Date: July 07, 2000

To: T10 Committee (SCSI)

Subject: Defining Targets/Initiators as Ports

What follows are suggested changes to SAM that would define targets and initiators as ports and allow multiples on a single SCSI device.

Figure 1 — Basic SCSI hierarchy

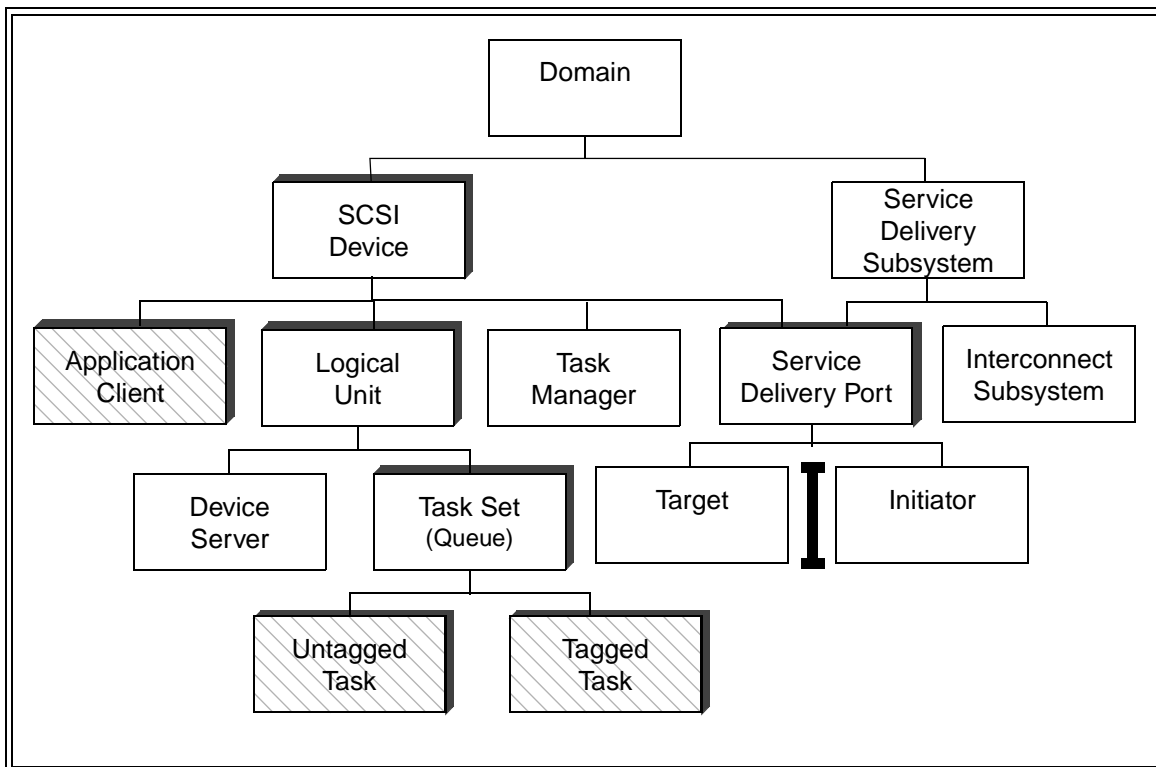
The following show the changes to figures in section 4 of SAM-2 that would be required to change to support a port = target/initiator model.

Figure 1 shows the main functional components of the basic SCSI hierarchy. The following clauses define these components in greater detail.

Figure 2 — SCSI Device hierarchy diagram

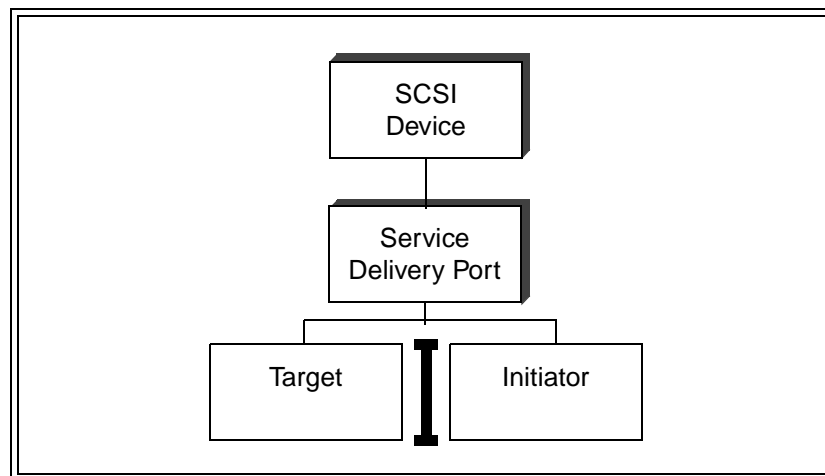
In the basic structural model, an SCSI device (see figure 2) is composed of a service delivery port (see 4.6) combined with an initiator, or a target, or both an initiator and a target. or multiple initiators and targets.

Figure 3 — SCSI device functional models

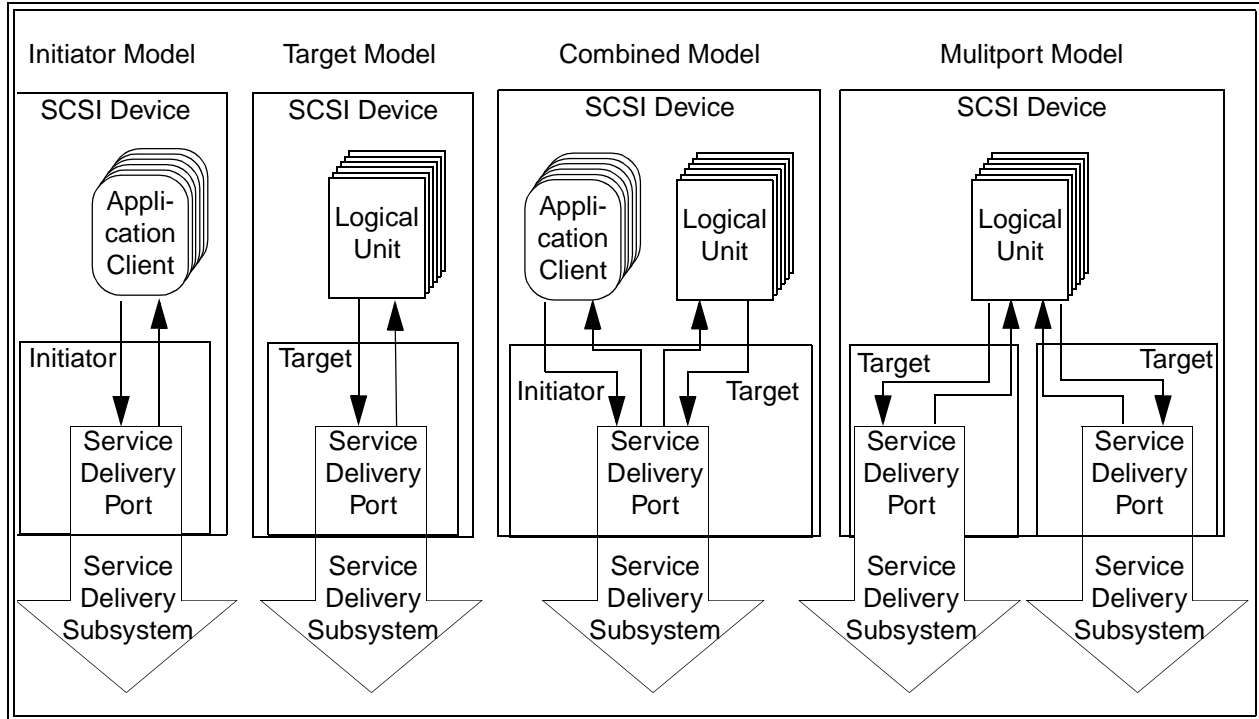
There are ~~three~~ four models for implementing initiator and target ~~capabilities~~ ports in an SCSI device, as shown in figure 3. An SCSI device may ~~perform~~ contain only target ports ~~functions~~, or only initiator ports ~~functions~~, or it may be capable of performing both functions.

Figure 4 — Initiator hierarchy diagram

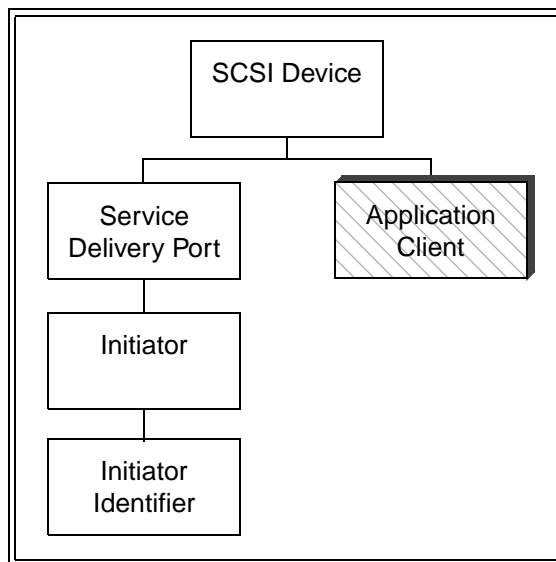
A SCSI device with an initiator port (see figure 4) is composed of an Initiator Identifier for each initiator port and zero or more Application Clients.

Figure 5 — Target hierarchy diagram

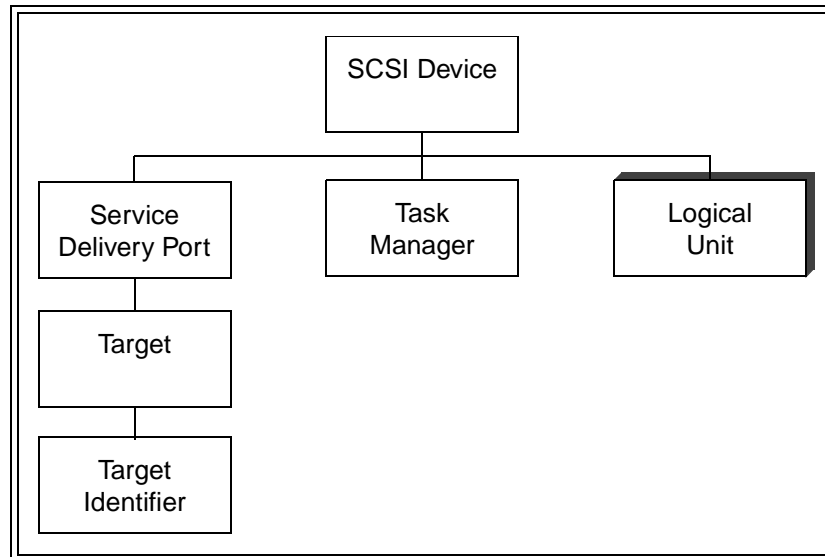
A SCSI device with a target port (see figure 5) is composed of a target identifier for each target port, a task manager, and one or more logical units.

Figure 6 — A SCSI multi-port unit and multiple SCSI domains

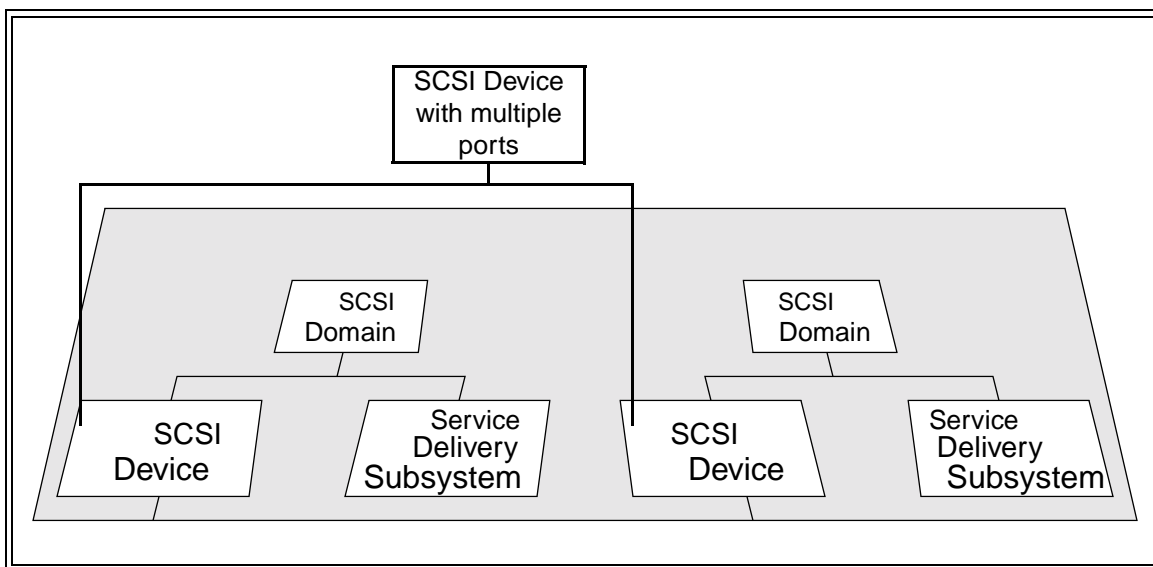
~~SCSI devices with Multi-port are objects in SCSI architecture model (see figure 6) that do not fit in the two dimensional hierarchy shown in 4.4. Instead, SCSI Multi-port Units they combine basic objects from the SCSI device model in a way that produces a different structural plane. Figure 6 also shows that SCSI devices from different domains may be connected to a single SCSI device with multiple ports. multiple SCSI devices instantiated by an SMU may be constituents of different SCSI Domains.~~

Figure 7 — SMU Multiple target port structure model

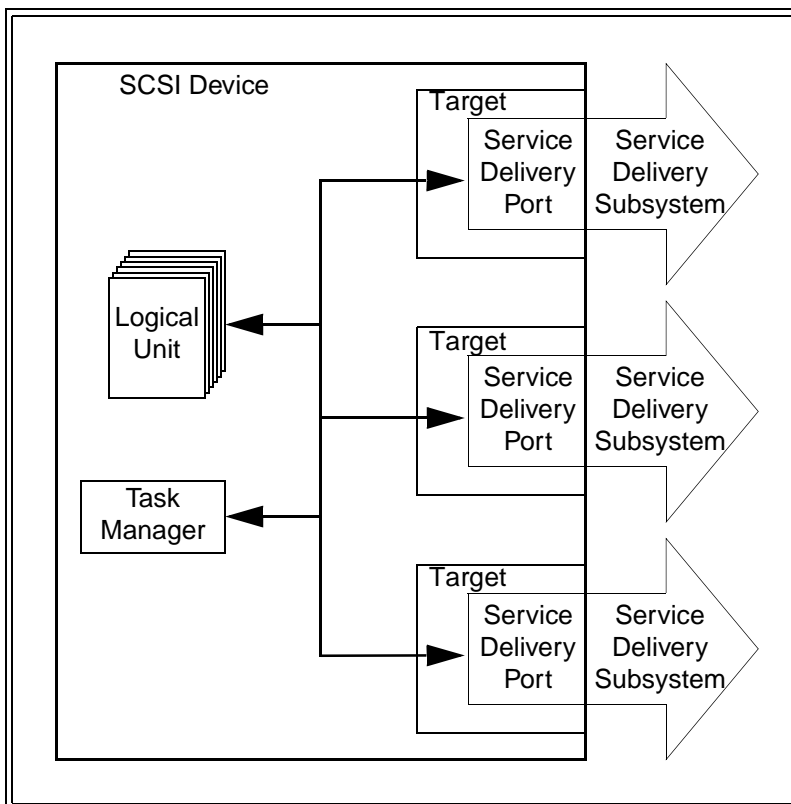
Figure 7 shows the structure of an SMU SCSI device with multiple target ports. A single task manager and collection of logical units share all the targets SCSI Devices and Service Delivery ports in the SCSI device SMU.

Figure 8 — SMU initiator structure model

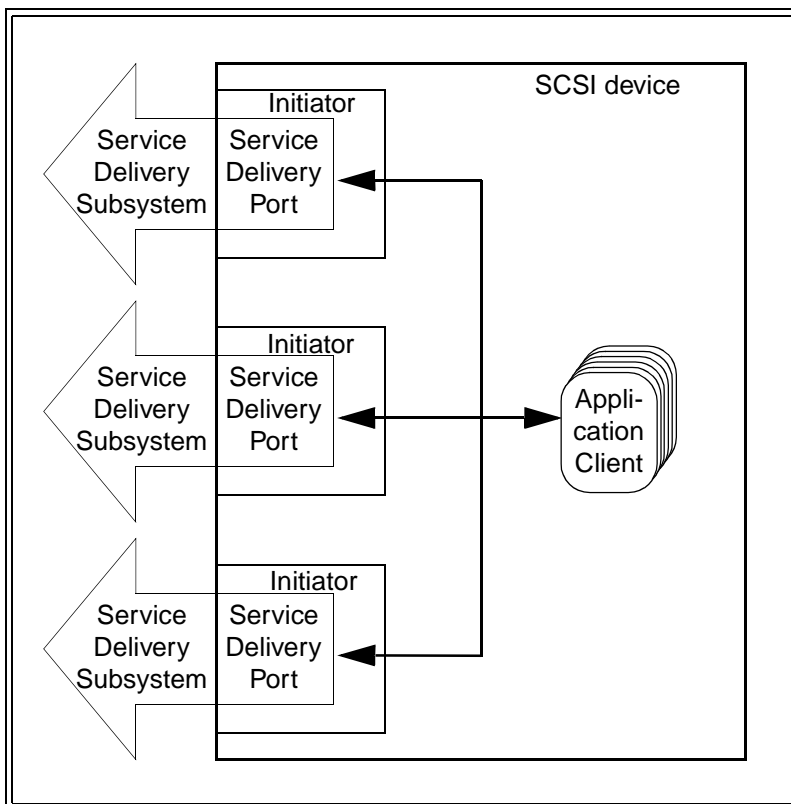
Figure 8 shows the structure of an SMU-SCSI device with multiple initiator ports. A collection of Application Clients share all the SCSI Devices initiator ports and Service Delivery ports in the SMU.

Figure 9 — SMU target SCSI device with target ports configured in a single SCSI Domain

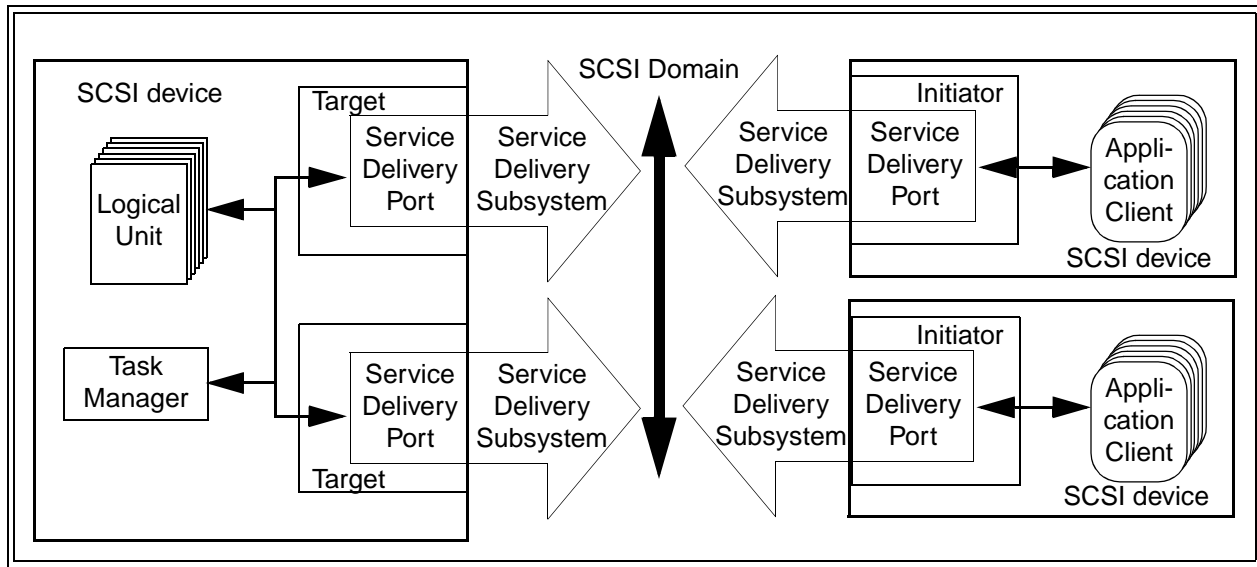
Figure 9 shows an SMU SCSI device with multiple target ports participating in a single SCSI Domain with two SCSI initiator devices. There are three SCSI devices, one of which has four service delivery ports in this configuration; two target ports for the SMU target, one with one initiator port, and one with one initiator port, one initiator port each for the two initiators. There are two Target Identifiers and two Initiator Identifiers in this SCSI Domain. Using the INQUIRY command Vital Product Data page as described in , the application clients in each of the SCSI devices that contain initiator ports have the ability to discover that logical

units in the SMU SCSI devices that contain target ports are accessible via multiple Target Identifiers (service delivery ports) and map the configuration of the SCSI devices-target.

Figure 10 — SMU target SCSI device with target ports configured in multiple SCSI Domains

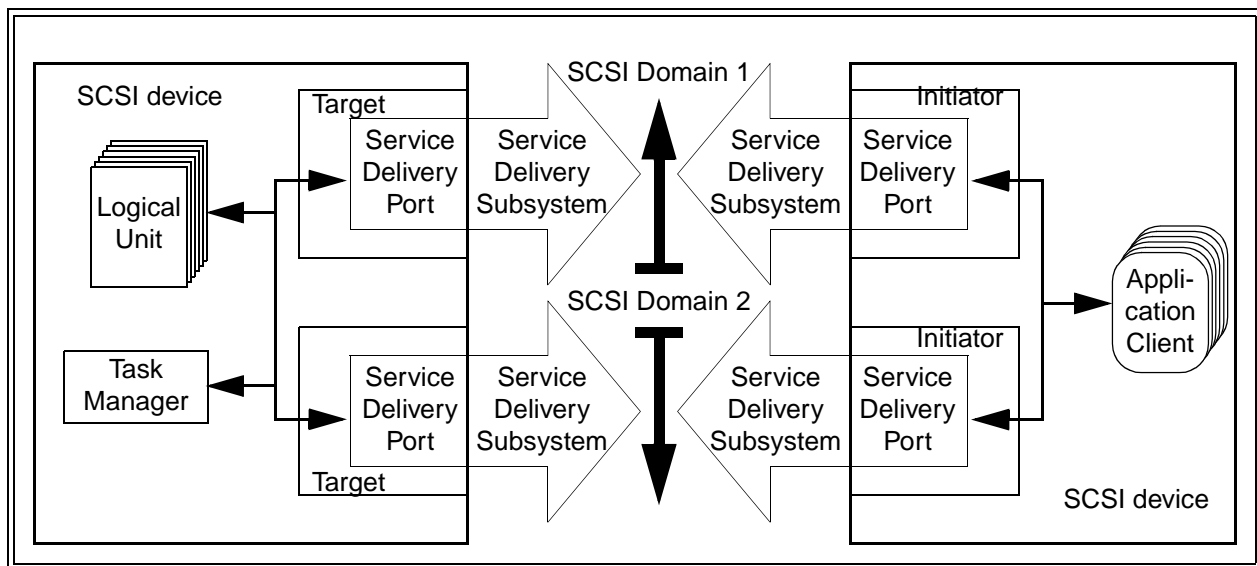
Figure 10 shows a SCSI device with multiple target ports an SMU target participating in two SCSI Domains and a SCSI device with multiple initiator ports an SMU initiator participating in the same two SCSI Domains. There are two SCSI devices, one with two target ports and the other with two initiator ports, four service delivery ports in this configuration, two for the SMU target and two for the SMU initiator. There is one Target Identifier and one Initiator Identifier in each of the two SCSI Domains. Using the INQUIRY command Vital Product Data page as described in , the application clients in the SCSI device containing initiator ports SMU initiator have the ability to discover that logical units in the SCSI device containing target ports SMU target are accessible via multiple service delivery ports in the SMU initiator and map the configuration. However, the methods available to application clients to distinguish between the configuration shown in figure 10 and the configuration shown in figure 22 may be beyond the scope of the SCSI family of standards.

Figure 11 — SMU target SCSI device with target ports and SMU initiator SCSI device with initiator ports configured in a single SCSI Domain

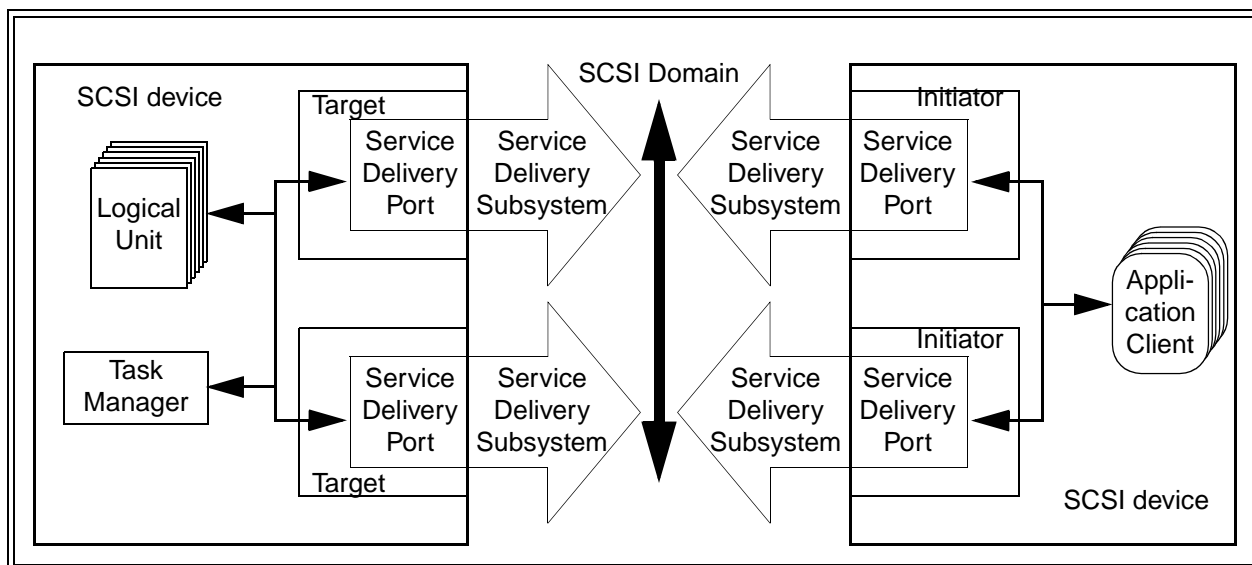
Figure 11 shows the same configuration as figure 10 except that the two SCSI Domains have been replaced by a single SCSI Domain.
